PROPOSED CHANGE ORDER REQUEST

Contract Name: Design/Build Roof Replacement & Painting of Steel Ground Storage Tanks at Scott Candler Water Treatment Plant **Date:** 6/1/2020
Contractor: Reeves Young LLC
Contract Number: 1073854 **Contract Amendment Number:** 2
Contract Amendment Category: Cost Schedule Scope Deliverables

**RE: Scott Candler WTP
 Steel Tank Repair
 Contract # 1073854
 Roof Replacement Tank #1**

Photograph No. 7:

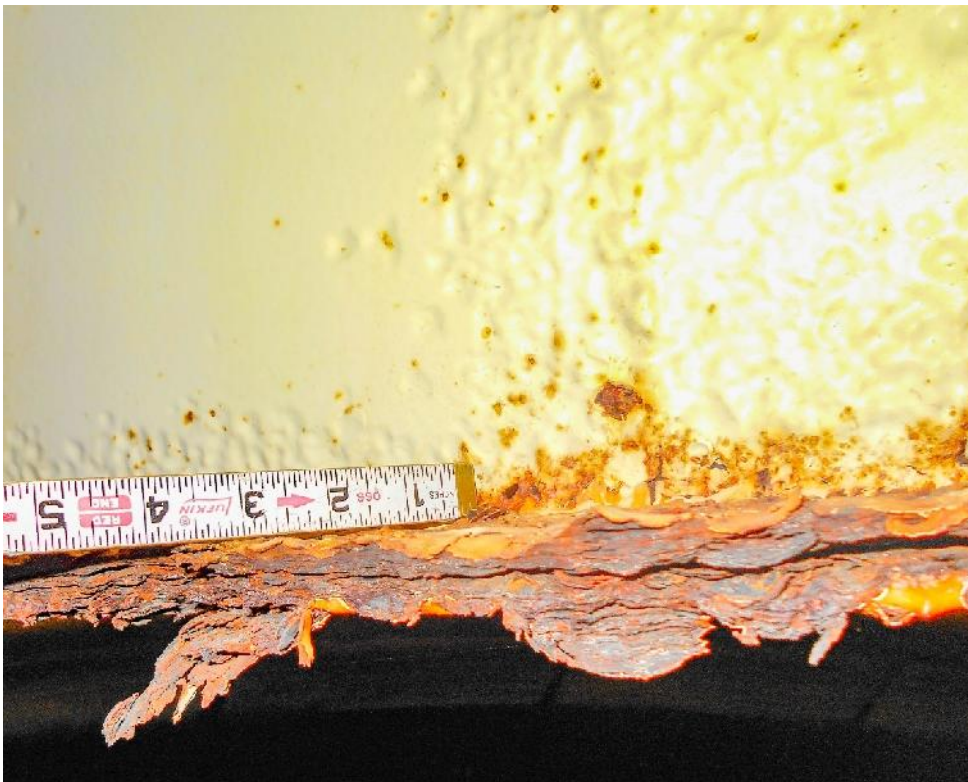
Representative example of major loss of section on tank roof short beam bottom flange.

Photograph No. 12:

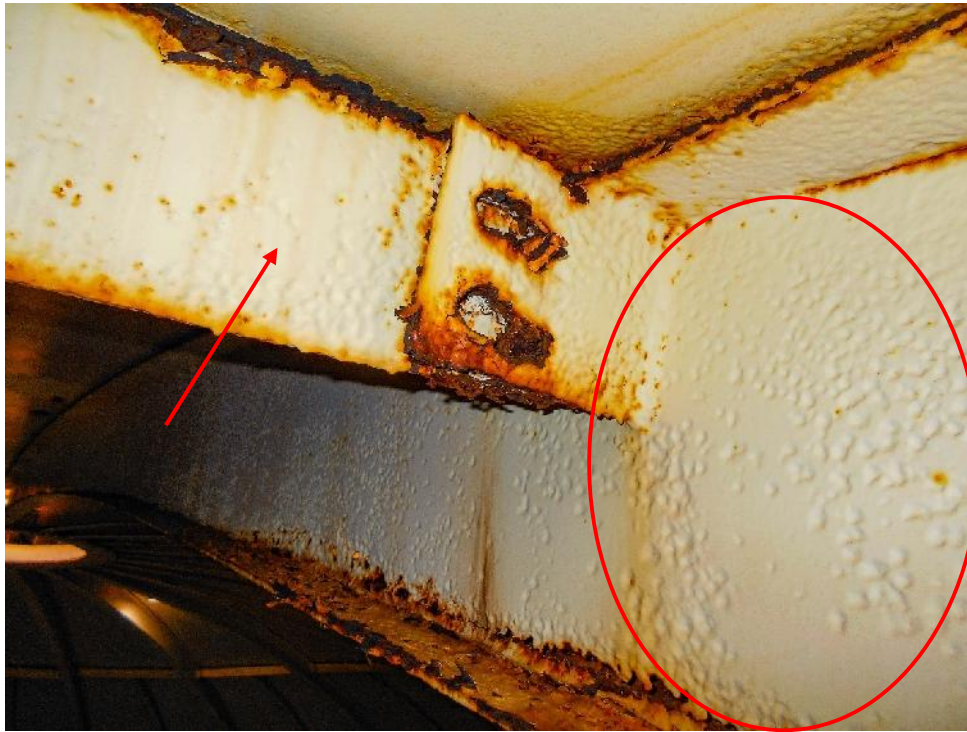
Advanced rust corrosion of short beam to transfer beam. Ruler is on the side of short beam.

Photograph No. 15:

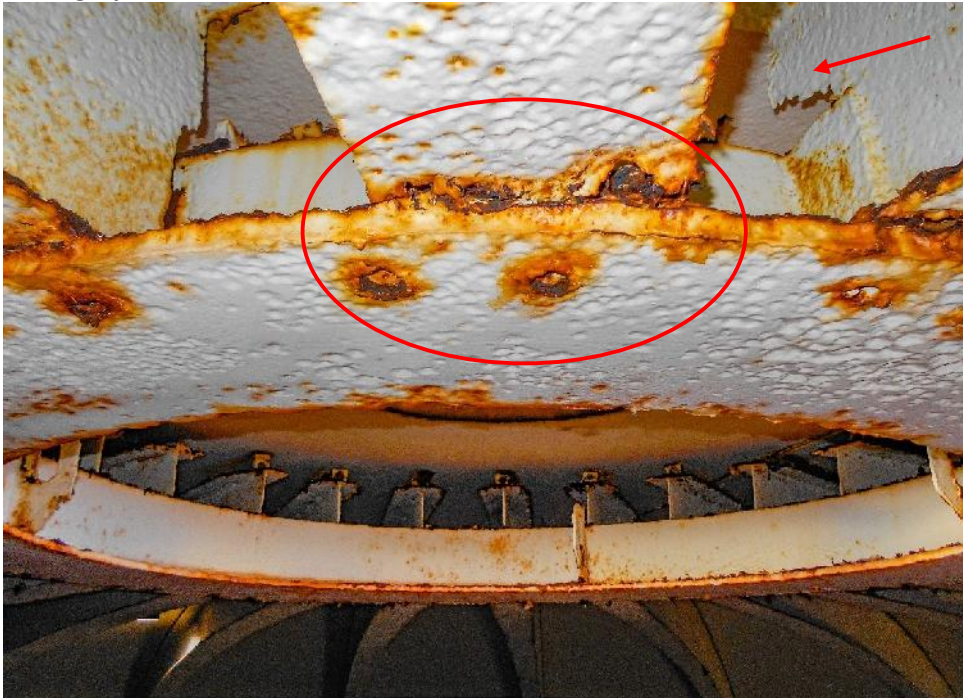
View looking up at center ring girder.

Photograph No. 18:

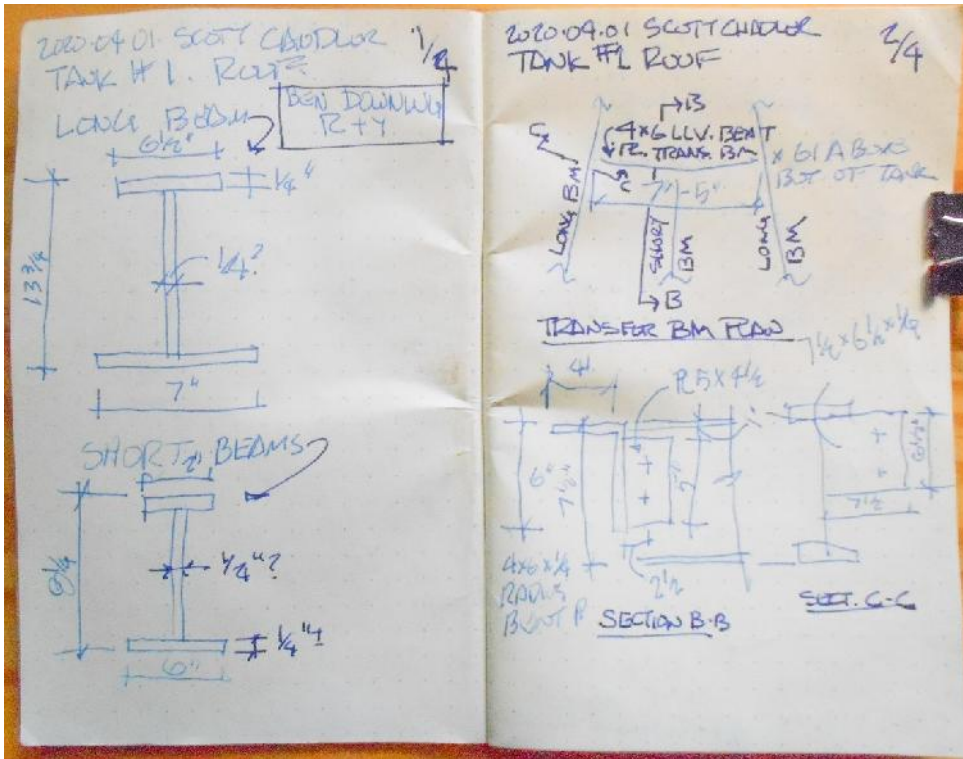
Sections of beam flange removed by hand. Section above ruler is advanced rusting flange steel with coatings on back side. Larger sections below the ruler are the outside surface of beam flange with coat still adhered.
